# Product/Process Change Notice (PCN)

PCN #: ConUSB\_20160513  
 Product Affected: 651005136521  
 PCN Date: May 27<sup>th</sup>, 2016  
 Effective Date: August 29<sup>th</sup>, 2016  
 Contact: Product Management  
 Tel: +49 7942 945-5001  
 Fax: +49 7942 945-5179  
 E-mail: [PCN.eican@we-online.de](mailto:PCN.eican@we-online.de)

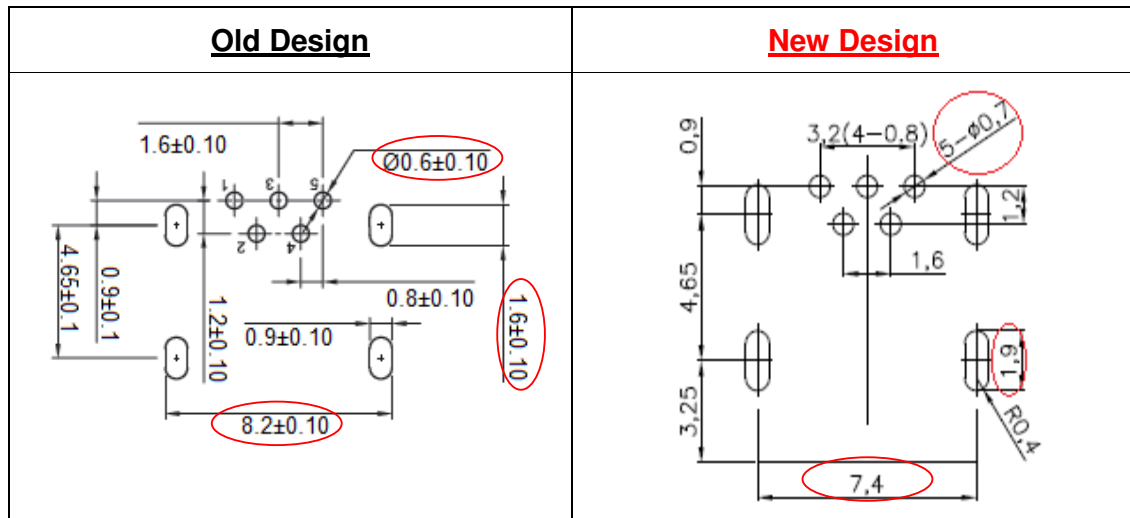
To ensure an improvement in product reliability and processability we changed the design of the product.

A fully automatized process will be implemented and CCD inspection controls will be added.

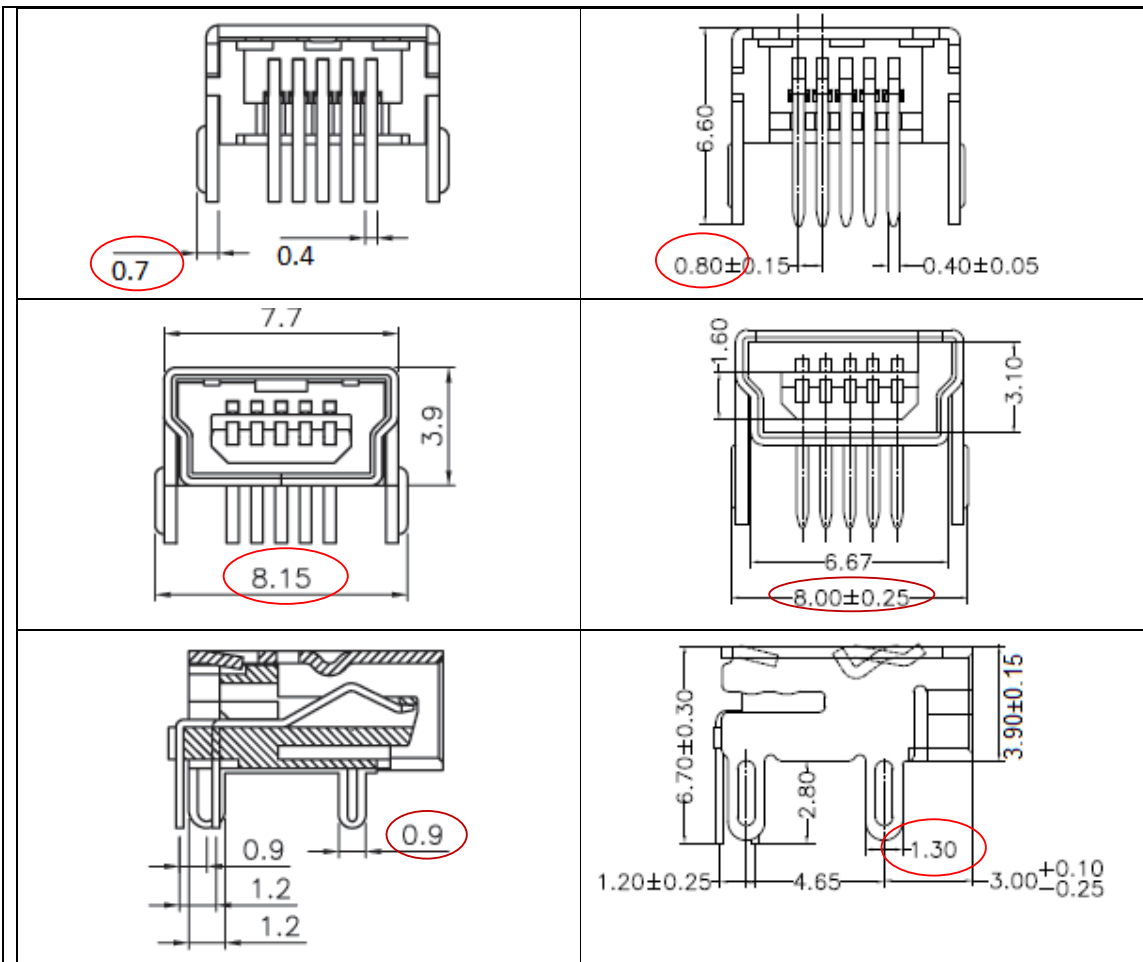
There are design changes but the electrical properties remain the same.

1. New version of product fits with previous layout and mechanical modifications are minor.
2. The packaging will be changed due to internal standardization
3. To enhance the product reliability, plastic is changed to High Temperature Plastic.

1. The design changes are summarized below and marked in red:
